STAFF REPORT

SUBJECT: H-2023-0004
Compass Pointe Subdivision

LOCATION: The site is located at 3245 & 3247 S. Locust Grove Road, in the NE ¼ of the NE ¼ of Section 30, Township 3N., Range 1E.

B. Preliminary Plat (dated: 3/7/2023 5/19/2023) (NOT APPROVED)

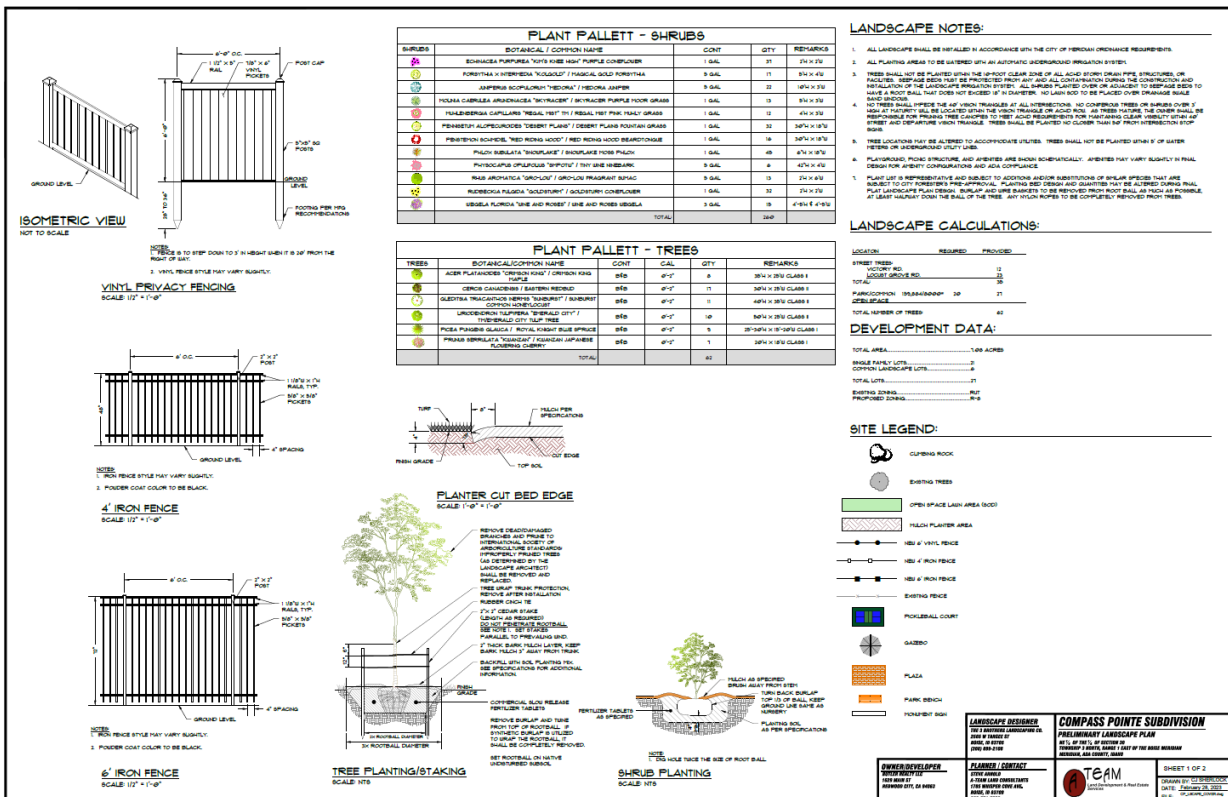
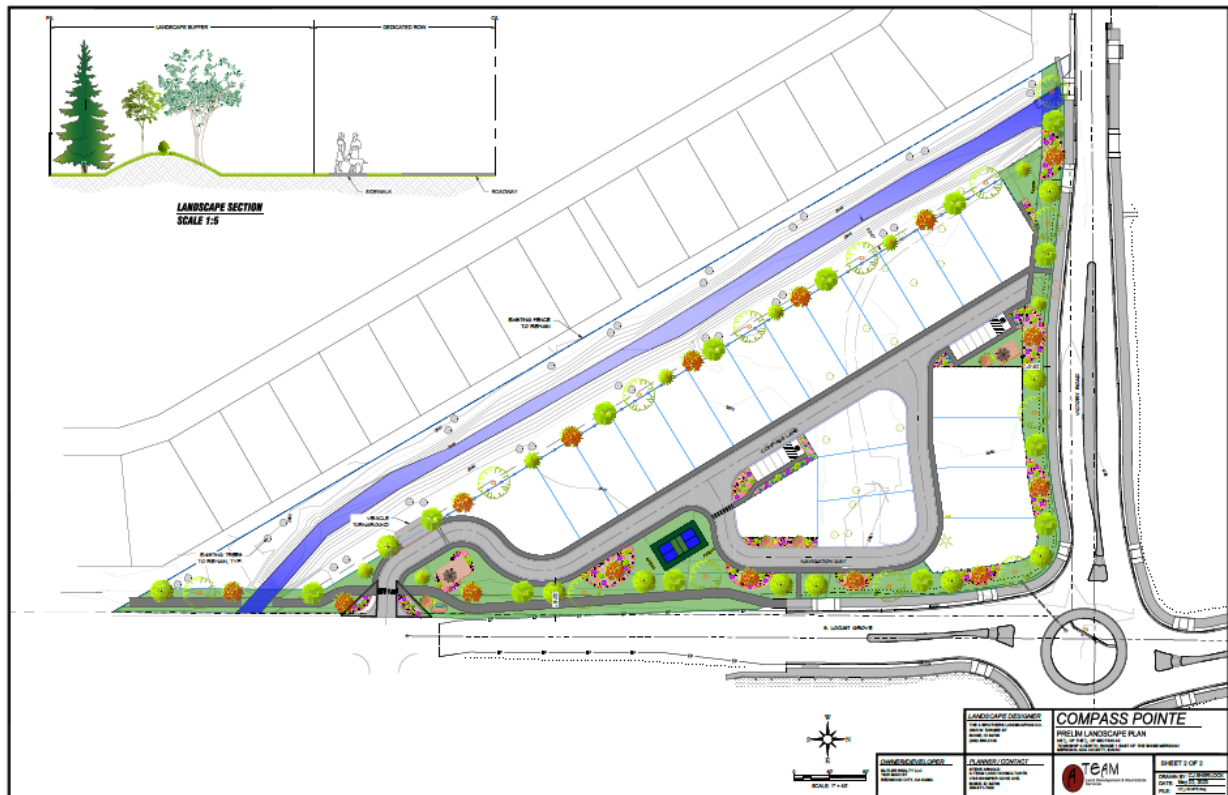
At the north end of the main street within the development (labeled as Compass Lane on the plat) the Applicant is proposing an emergency-only access to Victory Road. This access is required if more than 30 homes are to be constructed. Staff is not aware of the kind of emergency access proposed but Meridian Fire prefers bollard-type accesses for added efficiency in emergency situations; Meridian Fire has approved the requested preliminary plat for fire access, turnarounds, and road widths.

The proposed street sections (24 feet wide with attached sidewalk) of the private streets within the development, shown on the submitted preliminary plat, CANNOT accommodate parking on either side of the street. The entirety of the private streets will be required to be labeled as "No Parking," per the Meridian Fire recommendations. Each unit will be required to meet the off-street parking standards and Staff encourages the developer of this site to include provisions within their HOA bylaws that prohibit garages from being used as storage. This would help alleviate some of the parking issues seen throughout the City and especially in areas where no on-street parking is allowed.

The Applicant is also showing guest parking along the Compass Lane totaling 13 additional parking spaces. Lot 6, Block 3 is proposing 6 guest spaces, Lot 2, Block 2 is proposing 7 guest

- c. A final plat application shall not be submitted until the intersection improvements are substantially complete.
2. ~~At least fifteen (15) days prior to the City Council hearing,~~ The preliminary plat included in Section VIII.B, dated 3/7/2023, shall be revised as follows:

- a. ~~Revise the plat to depict a vehicle turnaround prior to the proposed entry gate to allow space for vehicles to back up.~~
 - b. ~~Revise the plat to show varying build to lines along the northern boundary within the development to eliminate any monotonous wall plane; this shall occur with every third structure showing a different wall plane.~~

- c. ~~Revise the plat to show the addition of a sidewalk connection to E. Victory Road from Compass Lane.~~
 - d. ~~Revise the plat to replace the proposed 5 foot wide sidewalk with a 10 foot wide sidewalk along S. Locust Grove Road connecting to the 10 foot wide sidewalk to be constructed by ACHD.~~

- e. ~~Revise the plat to show six (6) common lots instead of 7.~~
 3. ~~At least ten (15) days prior to the City Council hearing,~~ The landscape plan included in Section VIII.C, dated 3/1/2023 shall be revised as follows:

C. Landscape Plan (dated: ~~3/01/2023~~ 5/22/23) (NOT APPROVED)

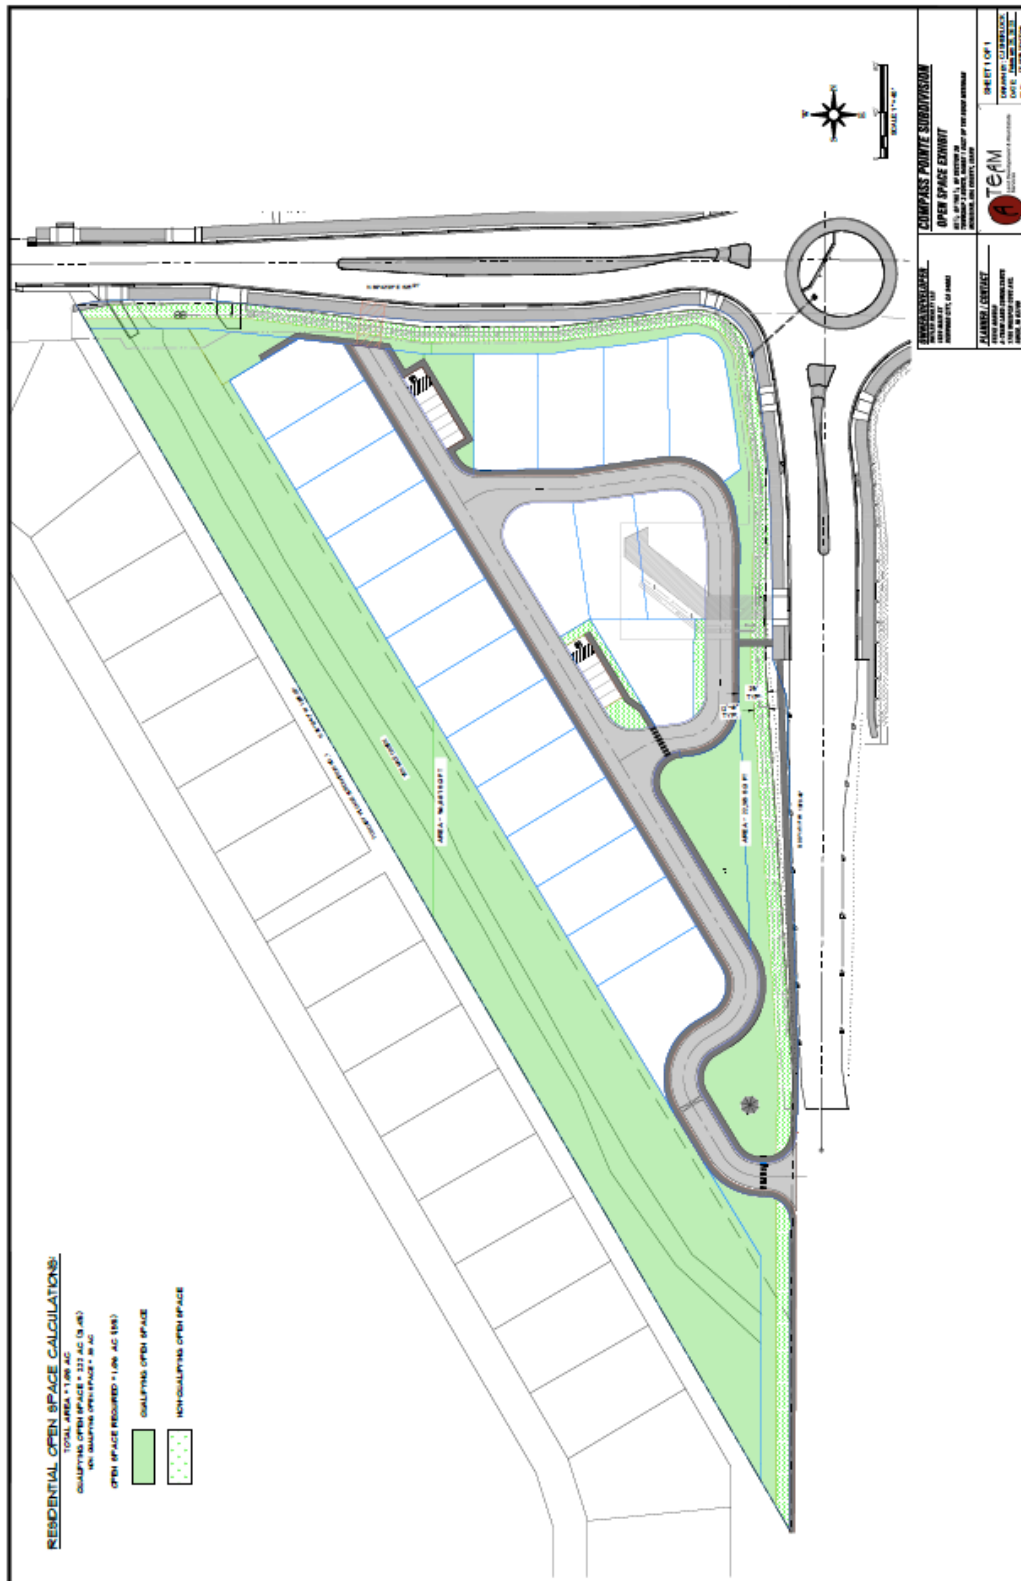
The submitted landscape plan and preliminary plat depict a landscaper buffer; the correct number of trees appear to be shown on the submitted landscape plans (see Section VIII.C). However, the width of the landscape buffers is not depicted on the landscape plan. The Applicant shall be required to submit revised plans that depict the width of the landscape buffers 15 days prior to the City Council Hearing. All required landscape buffers along streets shall be designed and planted with a variety of trees, shrubs, lawn, or other vegetative ground cover. Plant materials in conjunction with site design shall elicit design principles including rhythm, repetition, balance, and focal elements. ~~Staff recommends the Applicant revise The landscape plans appears to meet the standards in UDC 11-3B-7 (Landscape buffers along streets).~~ —See figures below.

Waterways: The Ten Mile Creek runs along the western boundary of the site. The irrigation easement is depicted on the plat and no encroachments are allowed within the easement area. *The landscape plan depicts a landscape buffer that looks to be at 5-feet in width adjacent to the irrigation easement line on the landscape plan meeting the UDC standards. ~~The Applicant should depict the width of the landscape buffer on the landscape plan.~~*

Fencing (UDC [11-3A-6](#), [11-3A-7](#)): All fencing is required to comply with the standards listed in UDC [11-3A-7](#). ***According to the submitted landscape plans, the Applicant is proposing three (3) types of fencing throughout the site, 6-foot vinyl solid fencing, 6-foot wrought iron fencing, and 4-foot wrought iron fencing.***

Fencing is shown on the landscape plan along the subdivision boundary, adjacent to the Ten Mile Creek, around the central open space lot along the northern portion of the site, and around the dog park. Fencing shown next to any open space shall be open-vision or semi-private fencing per UDC requirements. The landscape plan appears to be in compliance with this requirement.

- a. ~~Depict a turnaround prior to the proposed entry gate to allow space for vehicles to back up.~~
 - b. ~~Depict the width of the 25 foot wide landscape buffers along S. Locust Grove Road and E. Victory Road as well as the buffer width adjacent to the Ten Mile Creek.~~

- c. ~~Revise the landscape plan to show the addition of a sidewalk connection to E. Victory Road from Compass Lane.~~

- d. ~~Revise the landscape plan to replace the proposed 5-foot wide sidewalk with a 10-foot wide sidewalk along S. Locust Grove Road connecting to the 10-foot wide sidewalk to be constructed by ACHD.~~

- e. ~~Revise the landscape plan to meet the landscape buffer requirements in UDC 11-3B-7C.~~
 - f. ~~Include mitigation calculations on the plan for existing trees that are proposed to be removed in accord with the standards listed in UDC 11-3B-10C.5. The Applicant shall coordinate with the City Arborist (Kyle Yorita kyorita@meridiancity.org) to determine mitigation requirements prior to removal of existing trees from the site.~~
